No. 0510-032
ATA Code 57-30

SUBJECT: WING - WING ASSEMBLY - INSTALLATION OF STRAP BELOW WING AILERON PUSH ROD OPENING.

Service Instructions No. 0510-032

Installation of 169-110000-481 Strap

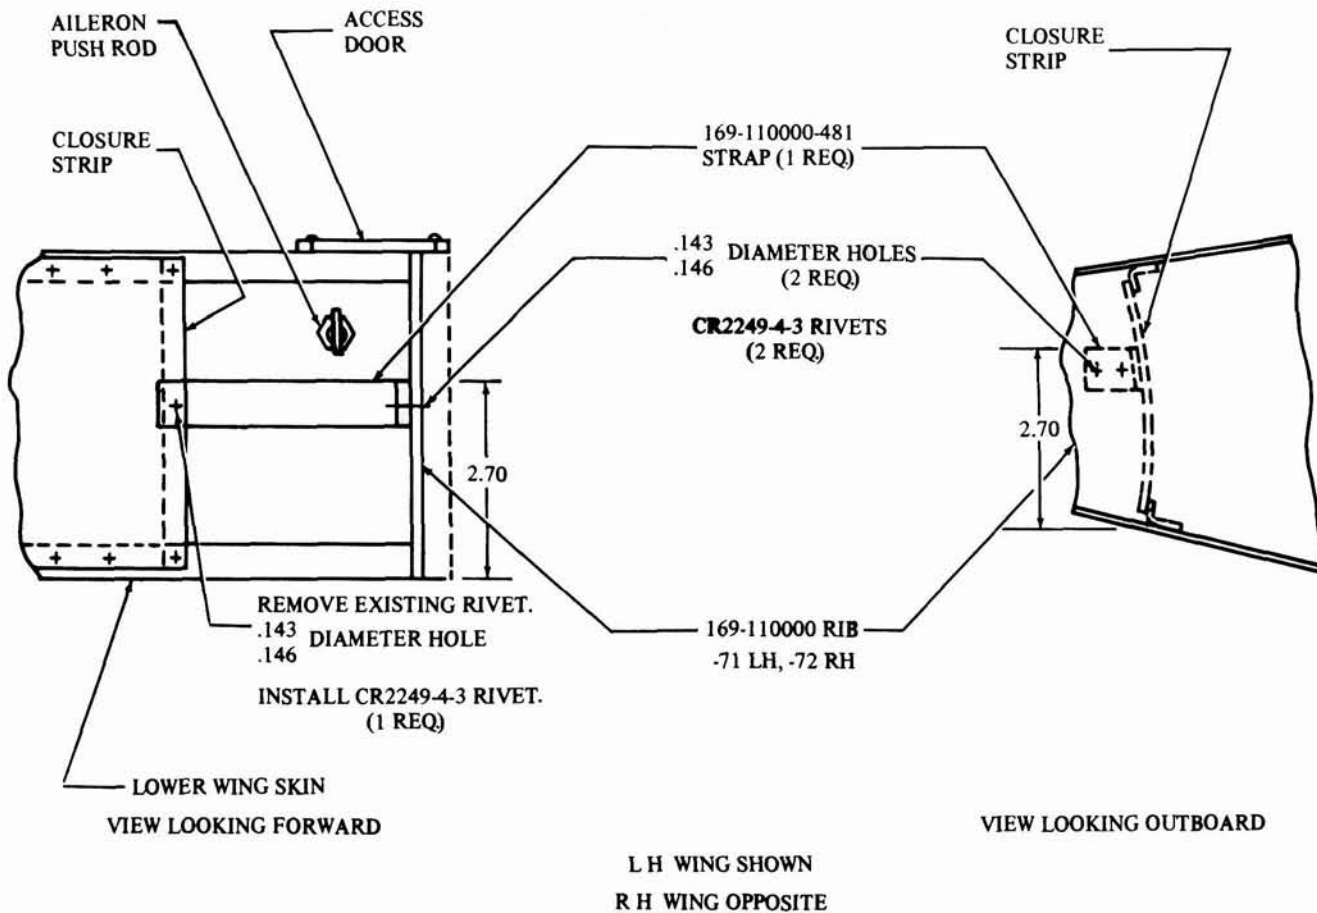
DESCRIPTION: A strap is installed across the opening in the wing closure strip under the aileron push rod.

1. Remove the aileron from one wing as described in the shop manual.
2. On the inboard end of the closure strip, remove the existing center rivet which is located approximately 2.10 inches up from the lower wing skin surface.
3. Locate the 169-110000-481 strap below the aileron push rod and between the closure strip and the 169-110000-71 or -72 rib and drill out the pilot hole in the -481 strap to .143/.146 diameter to align with the rivet hole in the closure strip. (See illustration.)
4. Backdrill through the -71 or -72 rib from the pilot holes in the flange of the -481 strap to .143/.146 diameter.

5. Install the -481 strap below the aileron push rod with three CR2249-4-3 Cherry Lock rivets.
6. Reinstall the aileron as described in the shop manual. Safety wire the outboard hinge bolt.
7. Repeat steps 1 through 6 on the opposite wing.
8. Check both LH and RH ailerons through full travel to see that the push rods clear the new brackets.
